**NOTICE TO BIDDERS D
HARBOR-UCLA MEDICAL CENTER REPLACEMENT PROGRAM
GENERATOR BUILDING RETROFIT PROJECT COMPONENT
BID NUMBER: BRC0000569
SPECS 7962; C.P. 67961**

April 16, 2025
REQUEST FOR INFORMATION/CLARIFICATIONS
HARBOR-UCLA MEDICAL CENTER REPLACEMENT PROGRAM
GENERATOR BUILDING RETROFIT PROJECT COMPONENT
BID NUMBER: BRC0000569

EXHIBIT 14 - Addendum D

1. Addendum D Narrative: Prepared by RBB Architects dated April 11, 2025

DU2-216.2

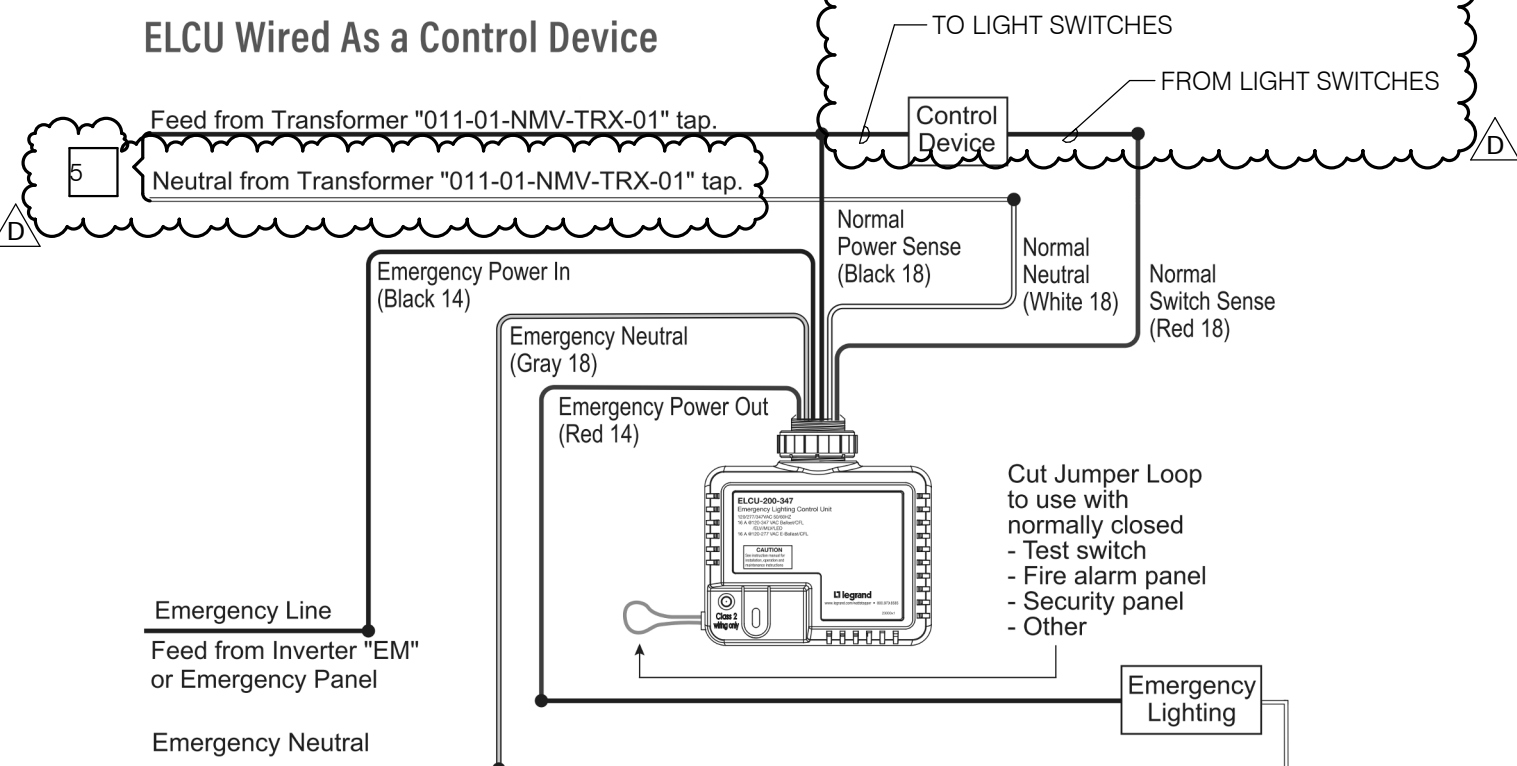
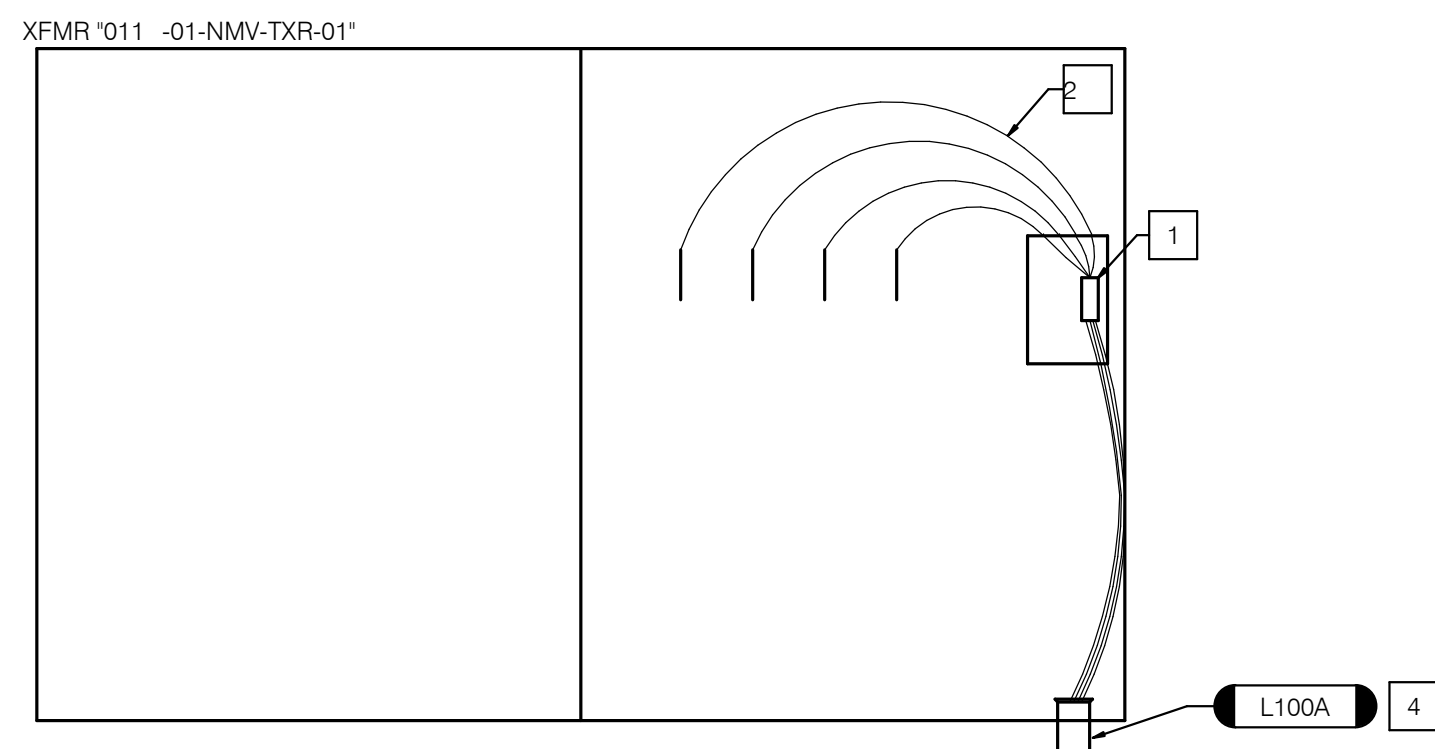
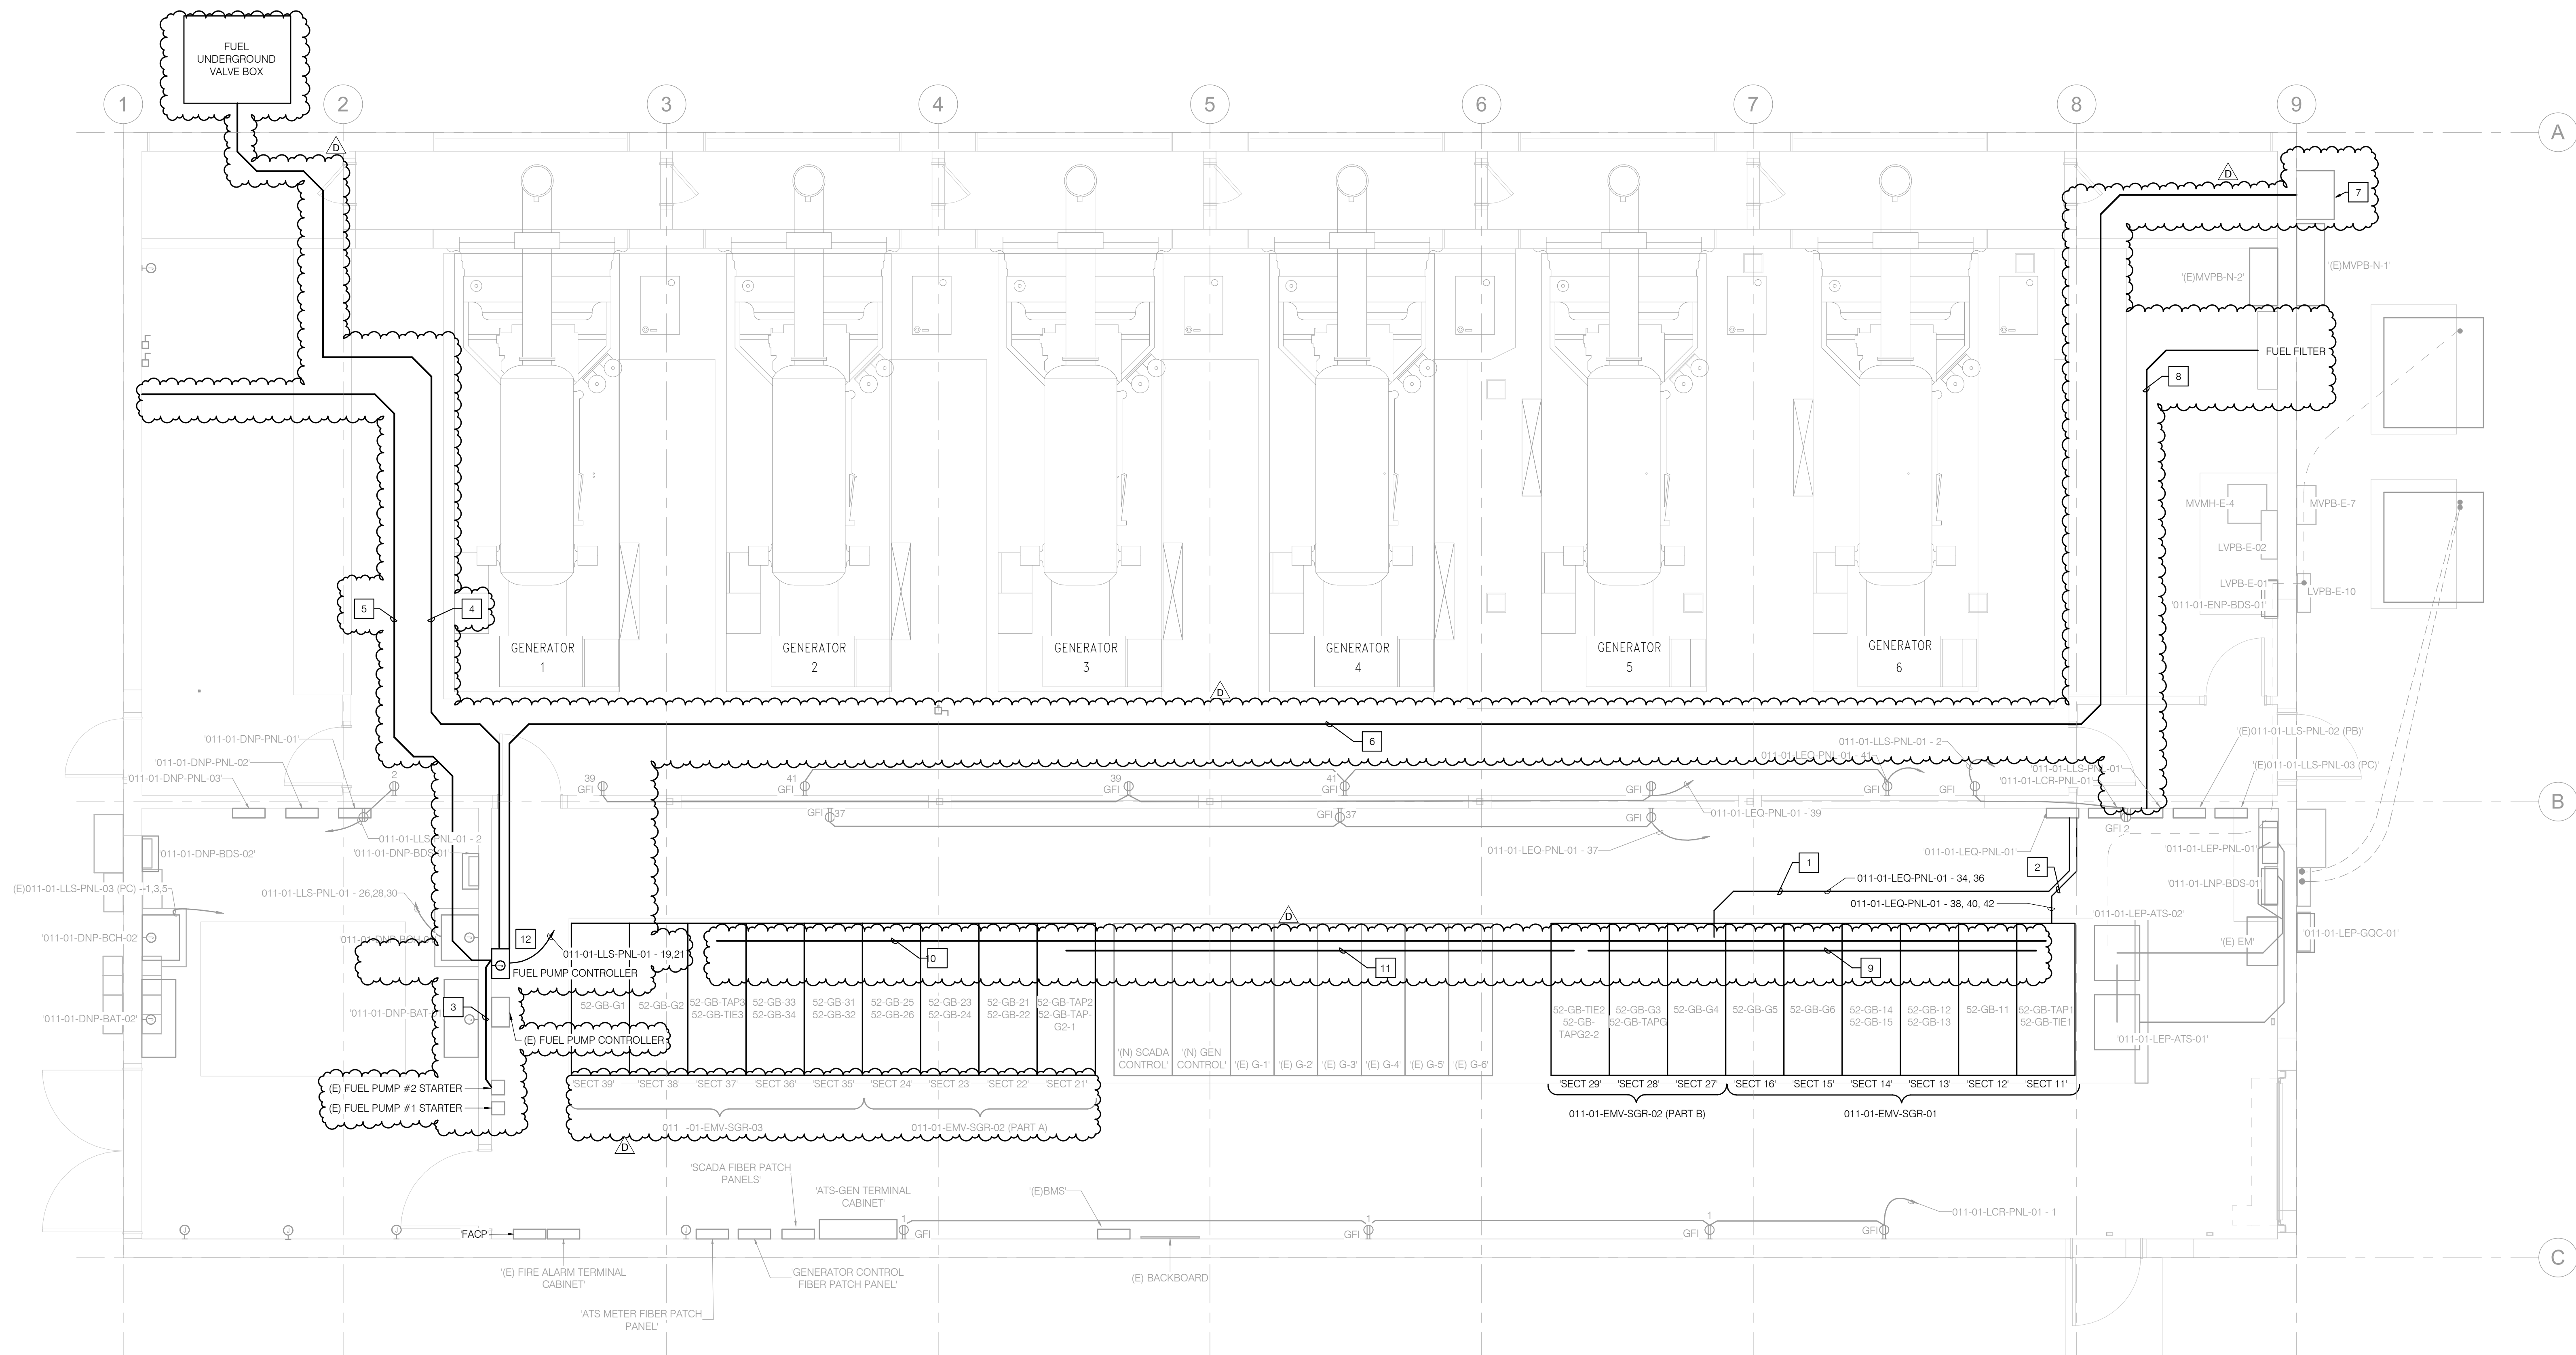
DU2-216.2 – Moved detail 2 and added tap detail added notes for tap. Changed circuits on some light circuits.

DU2-513

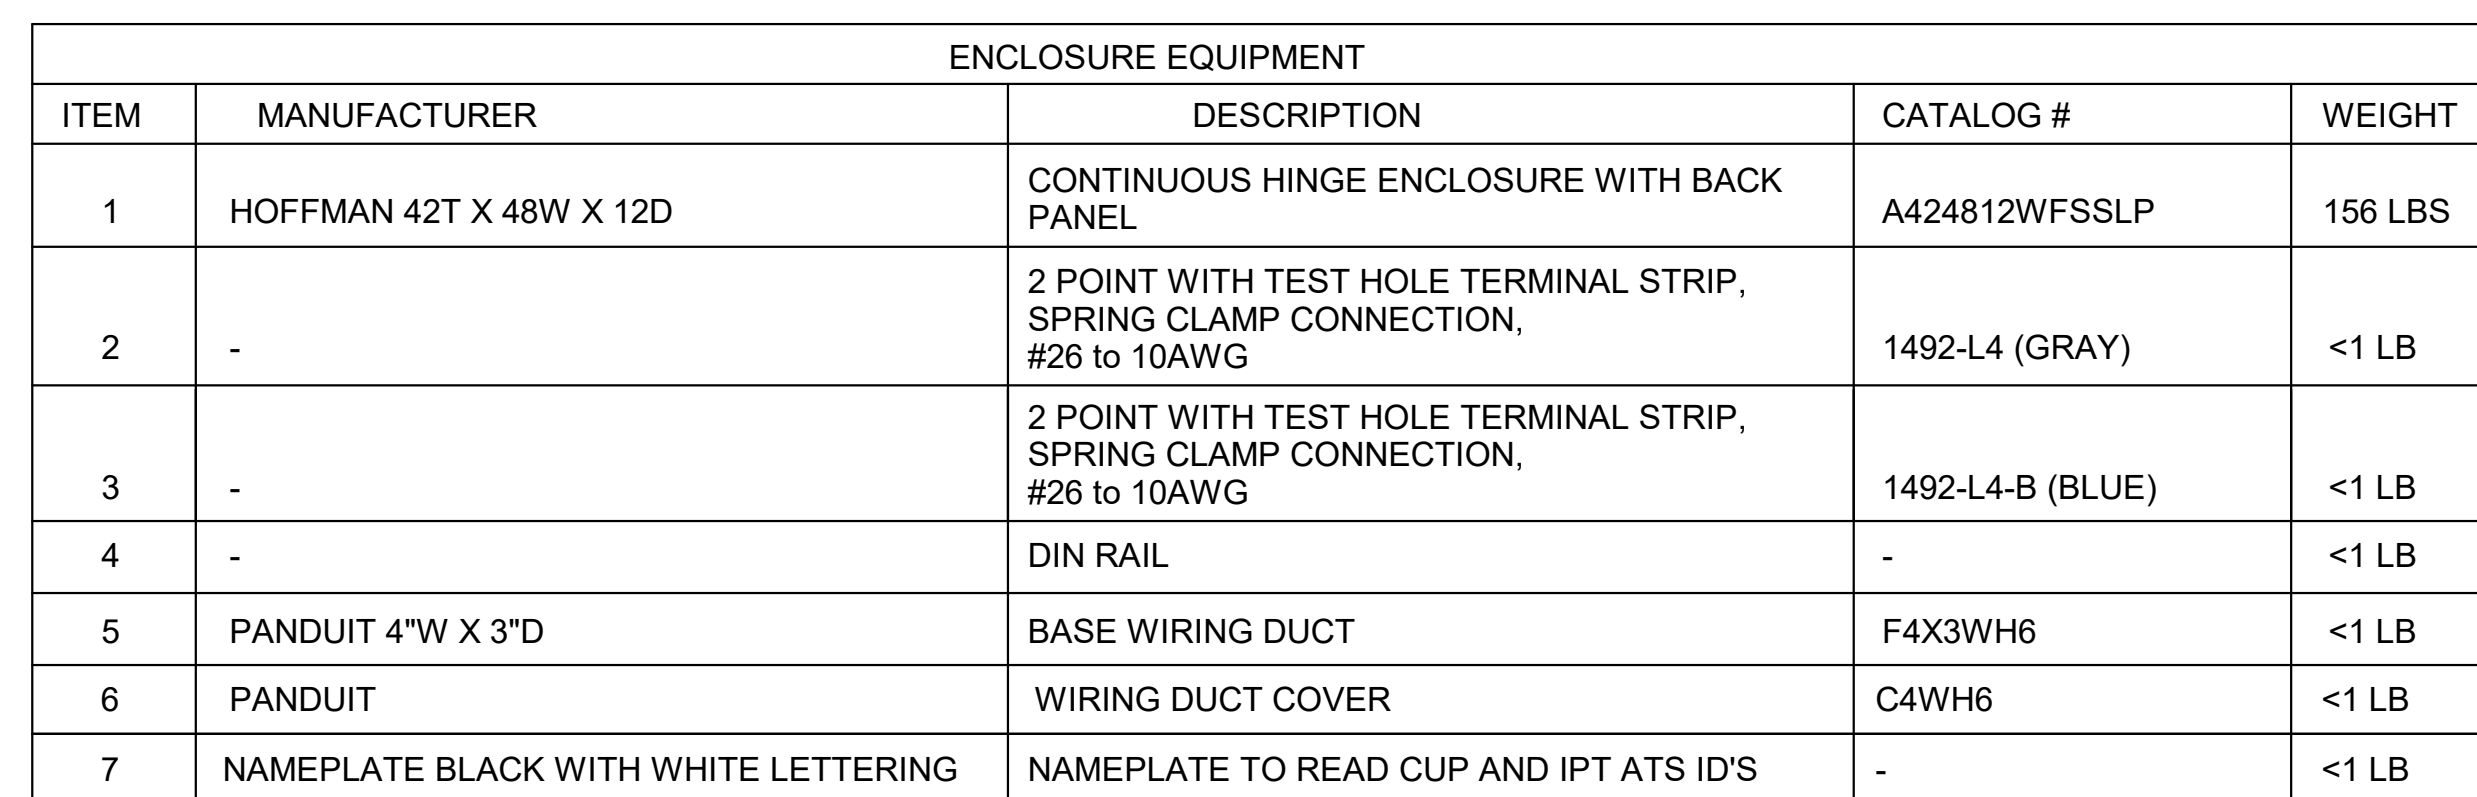
DU2-513 - Added additional requirements to general note 6.
